Access Compliance Report Public Rights-of-Way (Curb Ramps)

Main Street: RISILLA_ST Cross Street: VOLAR_ST Location: SW

ADA ID: RPRK211119132722 Ramp Type: Type 4 - Parallel Initial Pass/Fail: Fail Overall Compliance: No Severity Score: 19

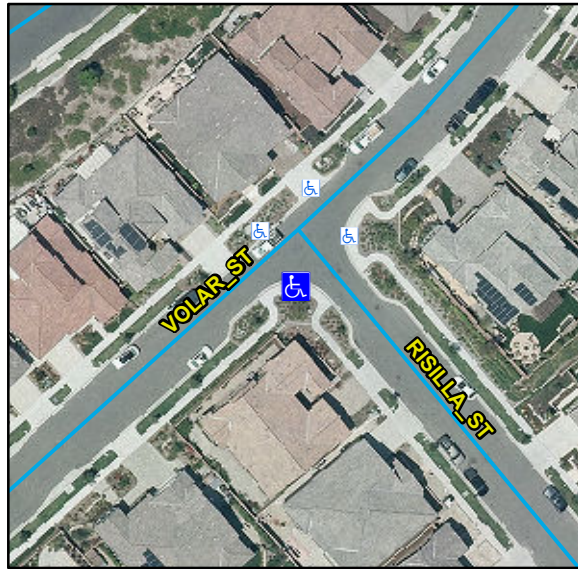
Compliance	Description	Data	Compliance	Description	Data
N/A	Ramp Length LT (in)	100	N/A	Ramp Length RT (in)	122
No	Ramp Width LT (in)	46	No	Ramp Width RT (in)	46
Yes	Ramp Run Slope LT (%)	5	Yes	Ramp Run Slope RT (%)	0.8
Yes	Ramp Cross Slope LT (%)	0.3	No	Ramp Cross Slope RT (%)	5.8
N/A	Landing Present	N/A	N/A	DWS Provided	N/A
N/A	Landing Length (in)	N/A	N/A	DWS Contrast	N/A
N/A	Landing Width (in)	N/A	N/A	DWS Length (in)	N/A
N/A	Landing Run Slope (%)	N/A	N/A	DWS Full Width	N/A
N/A	Landing Cross Slope (%)	N/A		DWS Offset Type	N/A
N/A	Landing Movement Obstructed?	N/A	N/A	DWS Offset Left (in)	N/A
	Landing Movement Type	N/A	N/A	DWS Offset Right (in)	N/A
N/A	Landing Shared	N/A			
N/A	Clear Space	Yes			
N/A	Clear Space To Crosswalk (in)	N/A			
N/A	Marked Crosswalk 1	No	N/A	Marked Crosswalk 2	No
	Crossing 1 Direction	E		Crossing 2 Direction	N
	Marked Crosswalk 1 Width (in)	N/A		Marked Crosswalk 2 Width (in)	N/A
N/A	Ramp Inside Crosswalk 1	N/A	N/A	Ramp Inside Crosswalk 2	N/A

Remove & Replace Curb Ramp With Two New Directional Ramps or Equivalent.
